**PLANNED UNIT DEVELOPMENT
& SUBDIVISION STAFF REPORT**

SUBDIVISION NAME Fielding Place Subdivision, Lot 5, Revised

LOCATION East terminus of Fielding Place (private street)

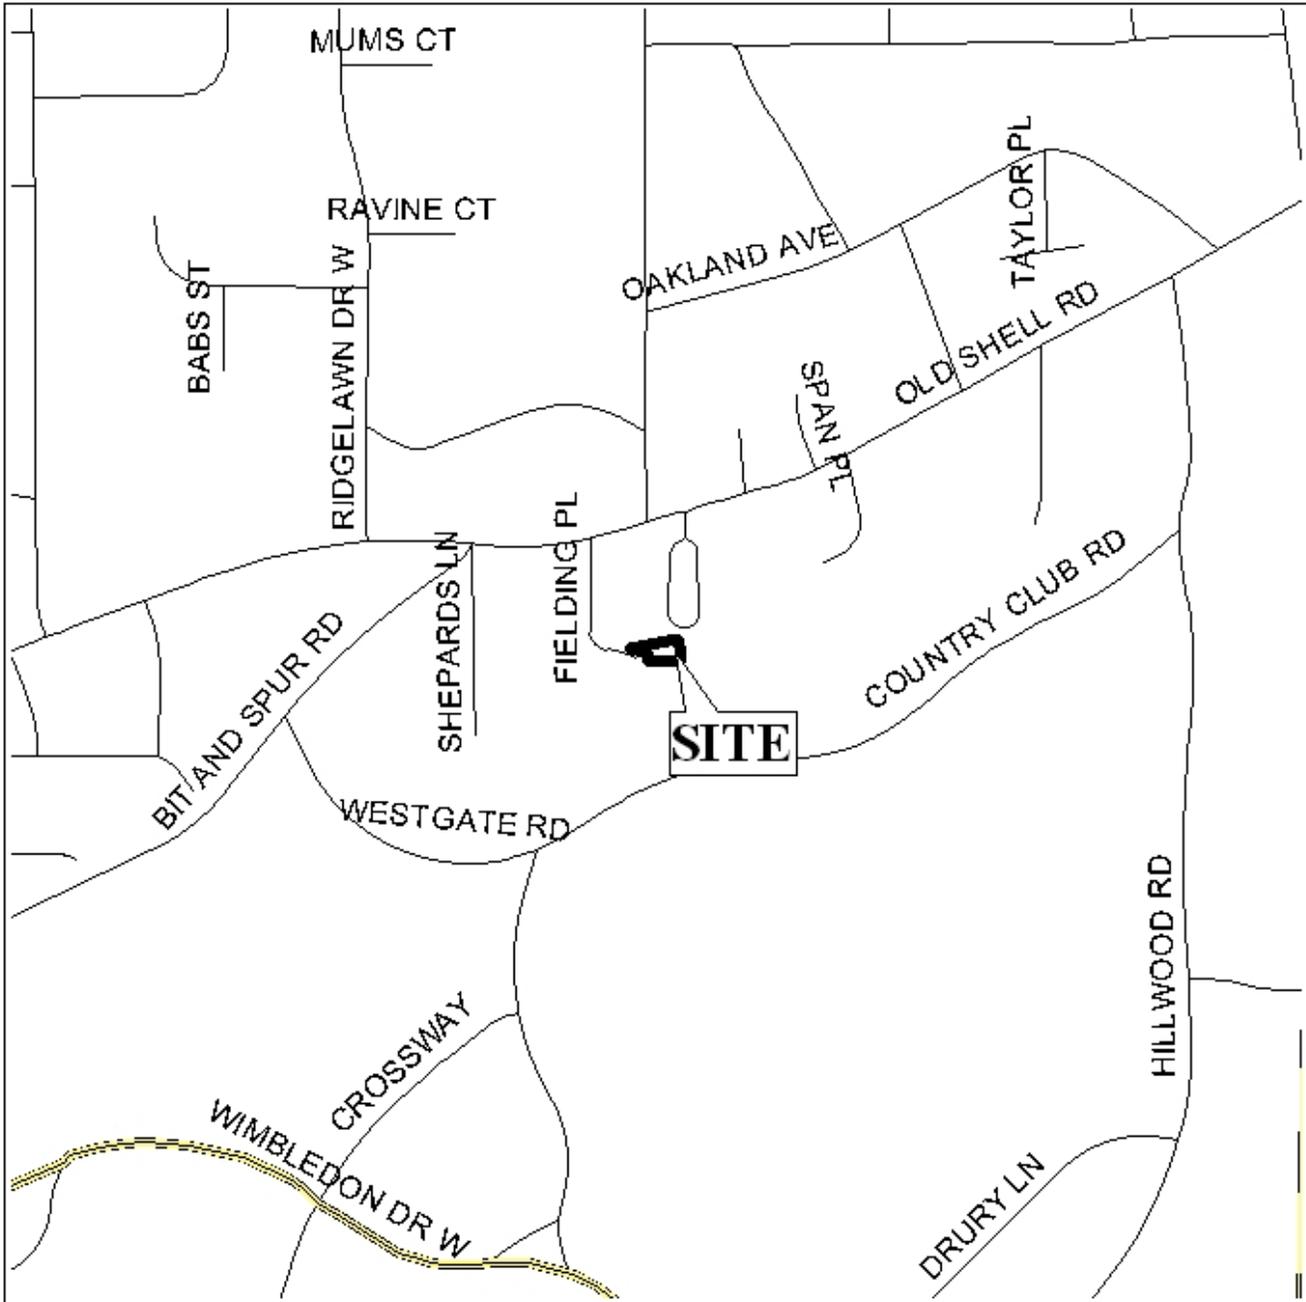
The plat and site plan now illustrate the following setbacks (original "building limits" in parentheses): 7 feet at the front/West side (14 feet for this lot; 10-foot typical for neighborhood); 6.25 feet at the closest point on the left/North side (7 feet at closest point); 3 feet at the rear/East side (14 feet). The right/South line is zero-lot line as before.

While the drawing represents encroachments on three sides, it should be noted that the original plat did not represent straight-line setbacks, but "building limits", which were not a consistent distance from the property line. Therefore, encroachment on the building limits does not always indicate that the structure is closer than the "minimum" shown elsewhere. In addition, the lot gets wider to the Northwest, so that a majority of the property does have more than 7 feet between the building and the North property line.

The principal change is in the increased site coverage, most of which occurs at the rear of the property. The rear adjoins the detention basin for the development, so encroachment over building limits would not impact another building site. The most significant concern would therefore appear to be whether the existing detention can accommodate the proposed site coverage.

RECOMMENDATION **Subdivision** *Based on the preceding, this application is recommended for Tentative Approval, subject to the following condition: 1) compliance with Engineering comments (The developer should provide a PLS certified survey of the existing detention pond and a PE certified evaluation of the existing detention pond to confirm the capacity and functionality of the existing system to accommodate the increased coverage. Development must comply with all stormwater and flood control ordinances. Any work performed in the right of way will require a right of way permit.).*

Planned Unit Development *Based on the preceding, this application is recommended for approval, subject to the following conditions: 1) compliance with Engineering comments (The developer should provide a PLS certified survey of the existing detention pond and a PE certified evaluation of the existing detention pond to confirm the capacity and functionality of the existing system to accommodate the increased coverage. Development must comply with all stormwater and flood control ordinances. Any work performed in the right of way will require a right of way permit.); and 2) full compliance with all municipal codes and ordinances.*
